SUNDRY NOTICES AND REPORTS ON WELLS Do not use this form for proposals to drill or to re-enter an abandoned well. Use form 3160-3 (APD) for such proposals.		Lease Serial No. NMNM120350 If Indian, Allottee or Tribe Name
SUBMIT IN TRIPLICATE - Other inst	ructions on page 2 NW OIL CONSERVATIO	7. If Unit or CA/Agreement, Name and/or No.
Type of Well Oil Well	ARTESIA DISTRICT	8. Well Name and No. HORNSBY 35 FEDERAL COM 10H

Cimarex Energy Co. respectfully requests approval for a multibowl well head. Please see attached diagram and procedure.

Hornsby 35 Fed Com 10H CACTUS FOR SERVICE WEARBUSHING IN CASING HEAD & CASING SPOOL

Multibowl Wellhead COA

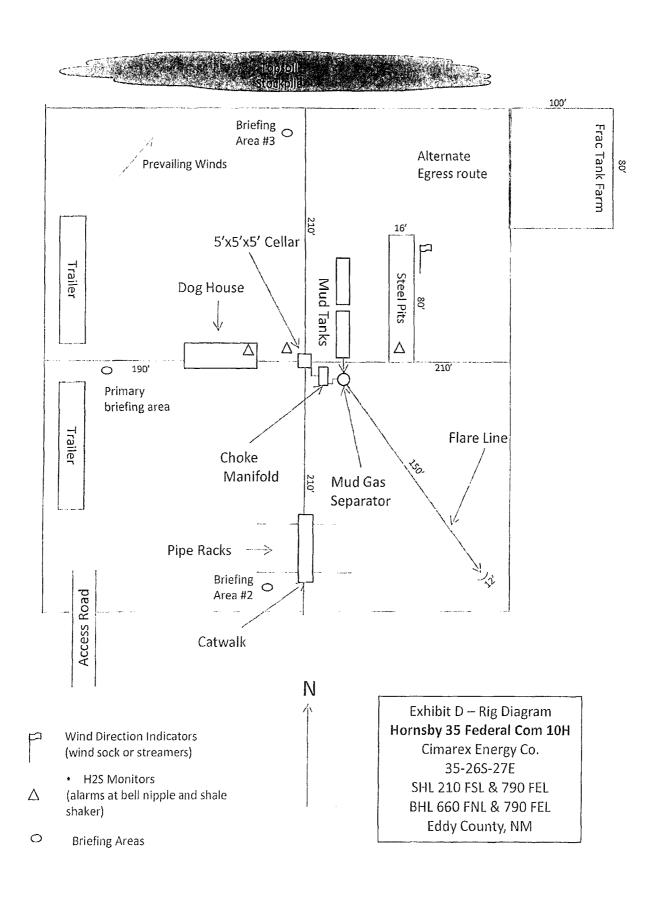
OK Pen Box Ballon 5-9-17 Ongine Engineering OK. All passines (at Still apply	exapt attached. TMAK 05/09/17		
14. I hereby certify that the foregoing is true and correct. Electronic Submission #375532 verified by the BLM Well Information System For CIMAREX ENERGY COMPANY OF CO, sent to the Carlsbad Committed to AFMSS for processing by TEUNGKU KRUENG on 05/09/2017 (17TMK0017SE)			
Name(Printed/Typed) ARICKA EASTERLING	Title REGULATORY ANALYST		
Signature (Electronic Submission)	Date 05/09/2017		
THIS SPACE FOR FEDERAL OR STATE OFFICE USE			
Approved By Cook left	Title AFM-Lands & Minus 5/10/17		
Conditions of approval, if any, are attached. Approval of this notice does not warrant or certify that the applicant holds legal or equitable title to those rights in the subject lease which would entitle the applicant to conduct operations thereon.	Office (FO

Operator has proposed a multi-bowl wellhead assembly. This assembly will only be tested when installed on the surface casing. Minimum working pressure of the blowout preventer (BOP) and related equipment (BOPE) required for drilling below the surface casing shoe shall be 3000 (3M) psi.

- a. Wellhead shall be installed by manufacturer's representatives, submit documentation with subsequent sundry.
- b. If the welding is performed by a third party, the manufacturer's representative shall monitor the temperature to verify that it does not exceed the maximum temperature of the seal.
- c. Manufacturer representative shall install the test plug for the initial BOP test.
- d. Operator shall perform the intermediate casing integrity test to 70% of the casing burst. This will test the multi-bowl seals.
- e. If the cement does not circulate and one inch operations would have been possible with a standard wellhead, the well head shall be cut off, cementing operations performed and another wellhead installed.
